Proposal for the third revision of the Signs and Signals on Inland Waterways (SIGNI)

(Resolution No. 22, revised)

Fifty-first session of the UNECE Working Party
on the Standardization of Technical
and Safety Requirements
in Inland Navigation

(fig. 3.11)

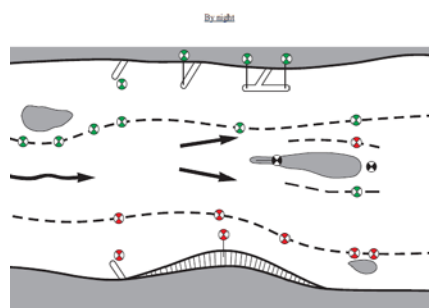
Fig. 3.11 (buoyage and marking by night) is not included in CEVNI

(fig. 3.12a)

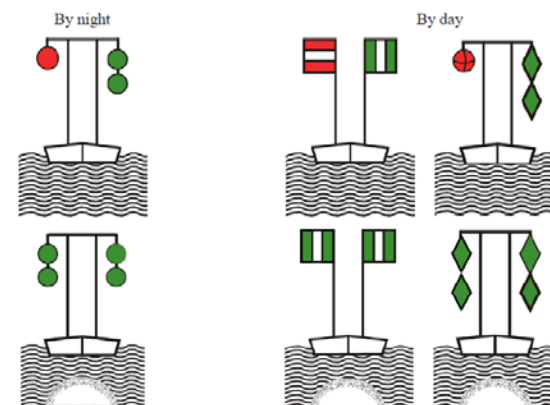
Fig. 3.12 is updated according to Annex 8 to CEVNI;
Fig. 3.12a – a discrepancy with CEVNI is identified (indication of an obstacle).

It is proposed to keep this figure in SIGNI.

(fig. 3.13)

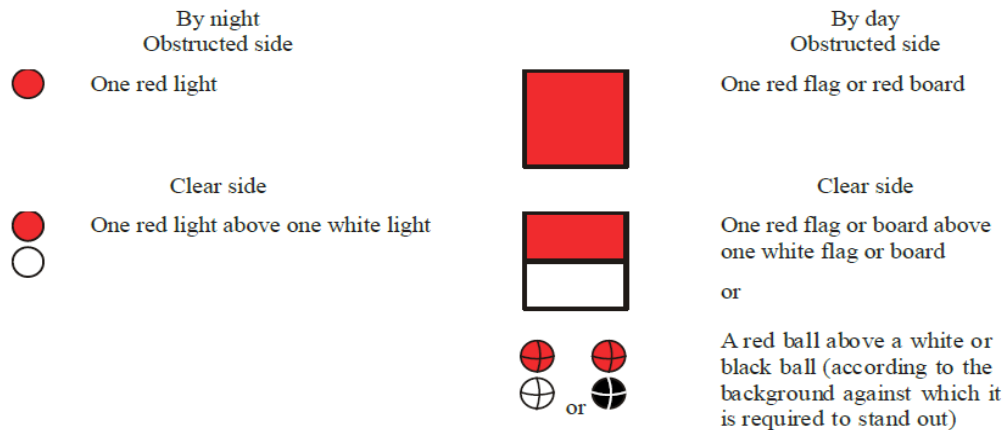
Missing in Annex 8
to CEVNI,
fig. 17 quater

(fig. 3.13a)

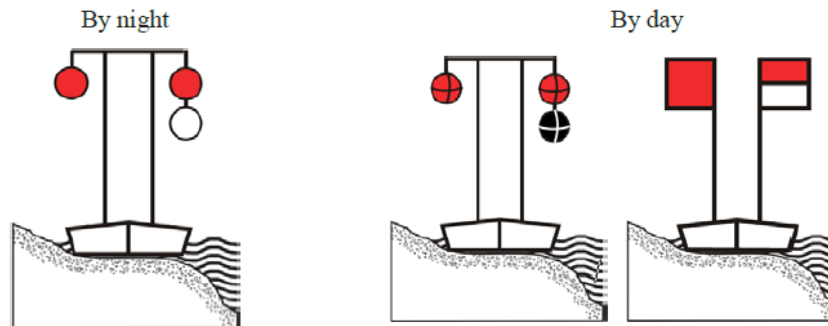
Differs from Annex 8
to CEVNI,
fig. 17 quinquies

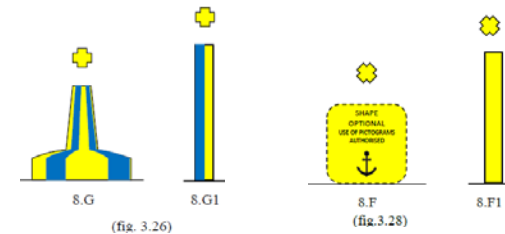
**Added from Annex 8 to
CEVNI, section VA
(see also Chapter 11,
INSTALLATION OF RADAR
REFLECTORS)**

**The Working Party may wish
to include these sketches in
Chapter 11**

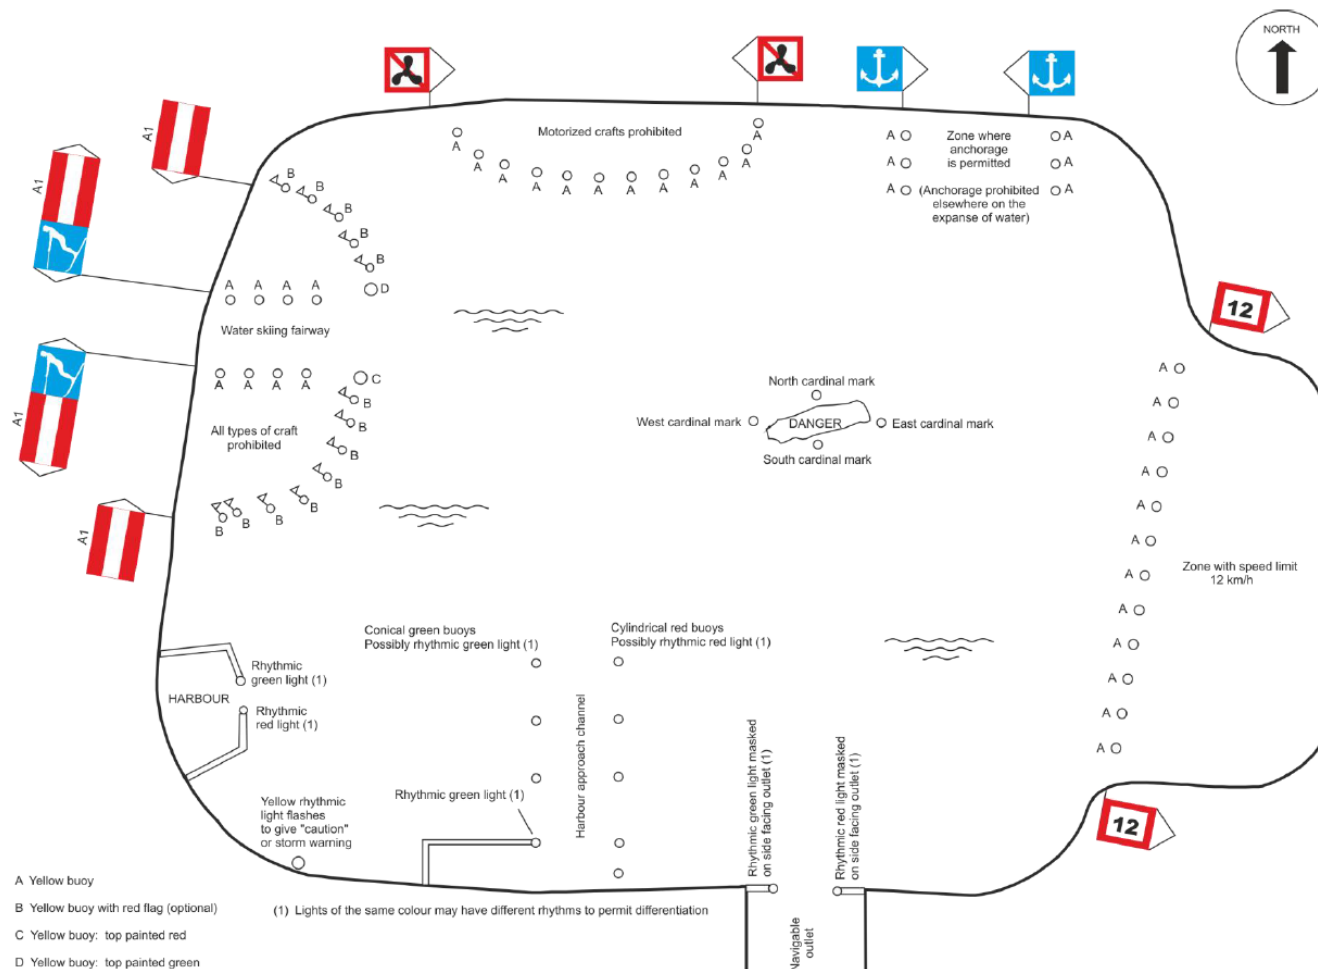
New marks according to ECE/TRANS/SC.3/WP.3/2017/5 are added (safe water marks, new dangers marks).

It is proposed to include there the following text:

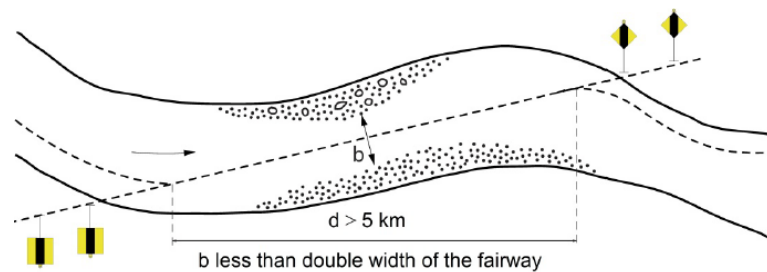
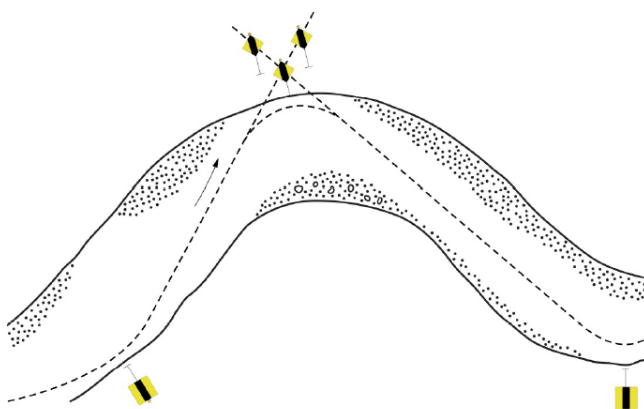
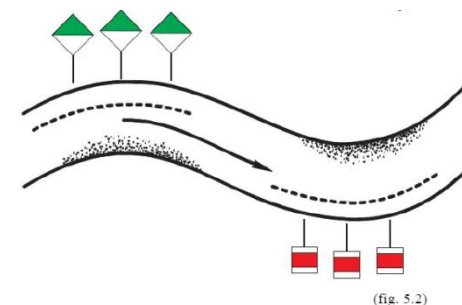
Fig. 14 (SIGNI) is added as Fig. 5.2, Figs. 17 and 18 are deleted, as they are duplicated by Figs. 5.3-5.6.
